Remarks

Objections to the drawings

FIG.1
PRIOR ART

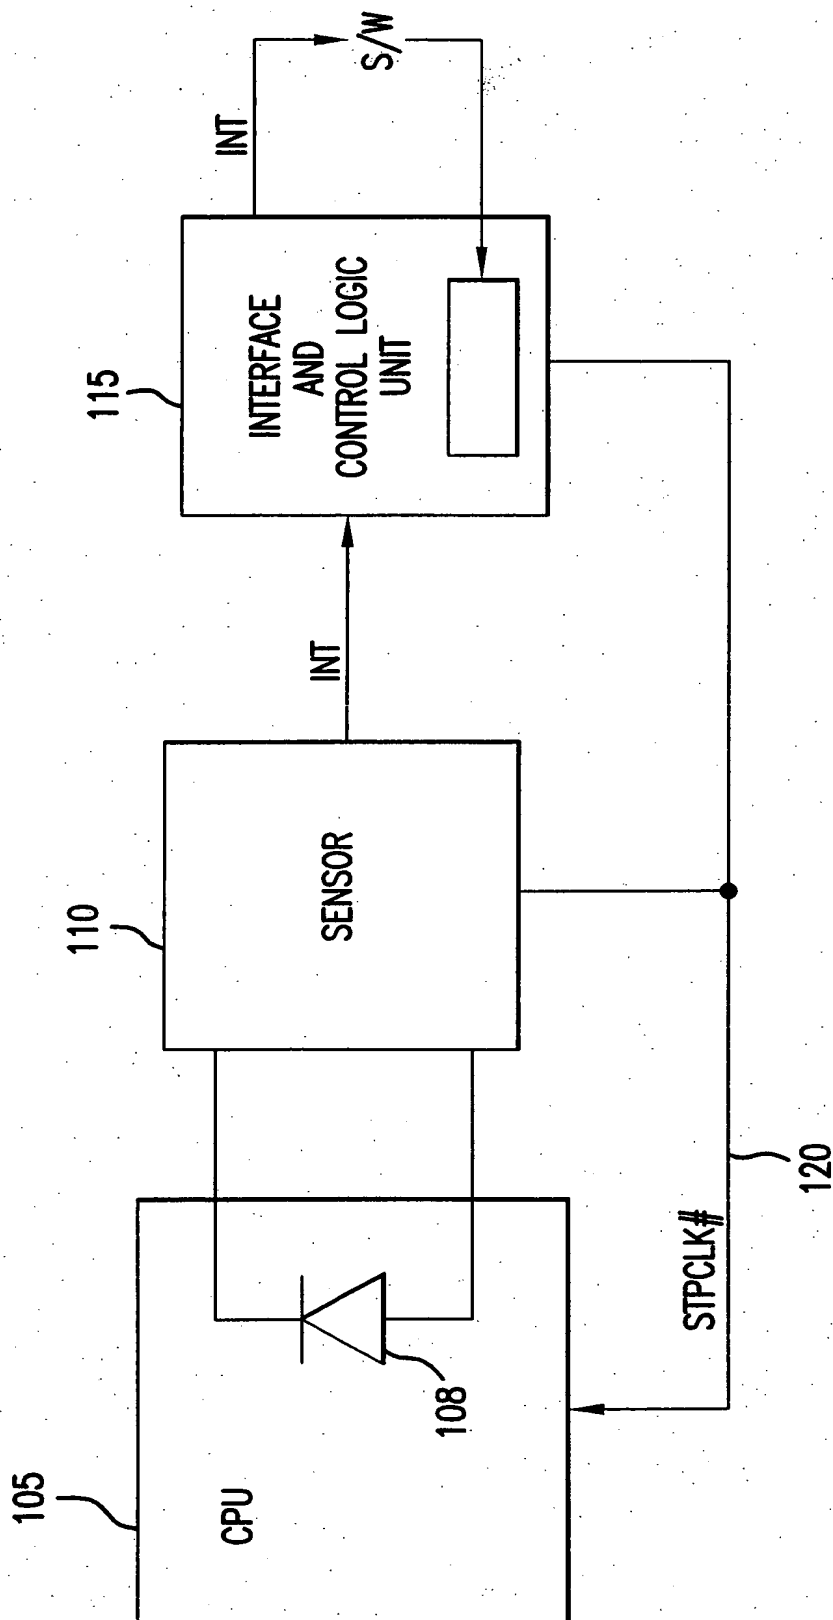
FIG. 1 was objected to. In accordance with the suggestion of the Office Action, the legend "PRIOR ART" has been added to FIG. 1. Withdrawal of the objection is therefore respectfully requested.

FIG.6

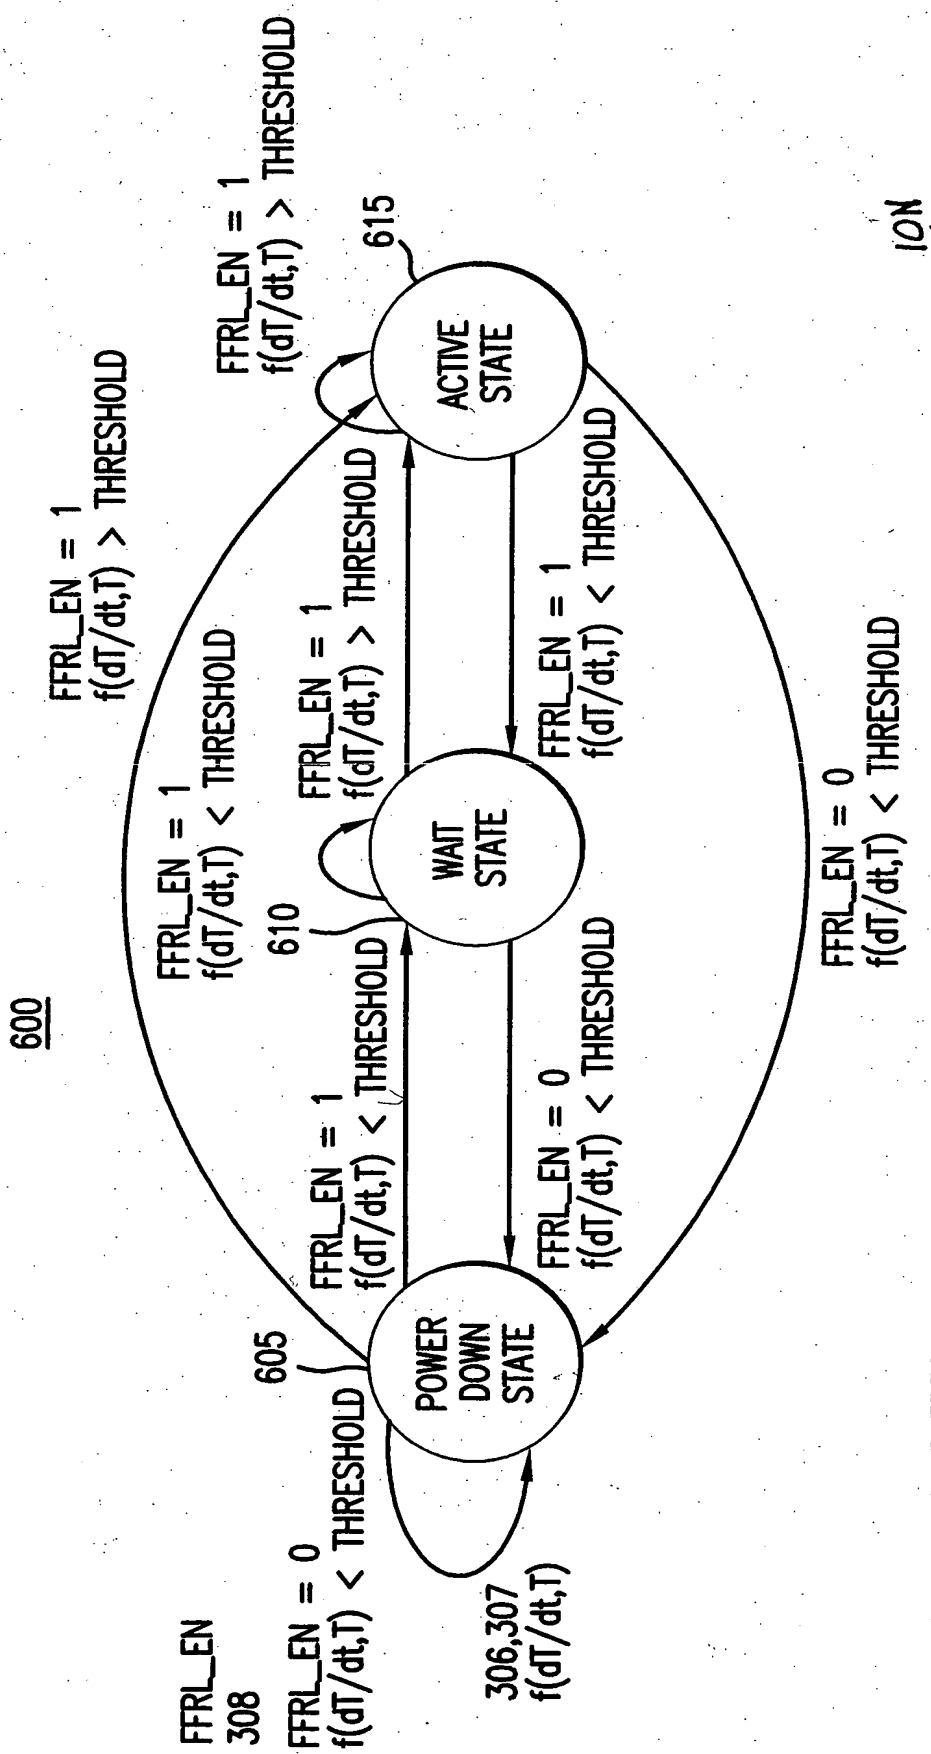
FIGs. 5 and 6 were objected to. Withdrawal of this rejection is respectfully requested in view of the amendment to FIG. 5 submitted herewith.

FIG. 6, though not objected to, has been amended to correct a minor informality noted therein.
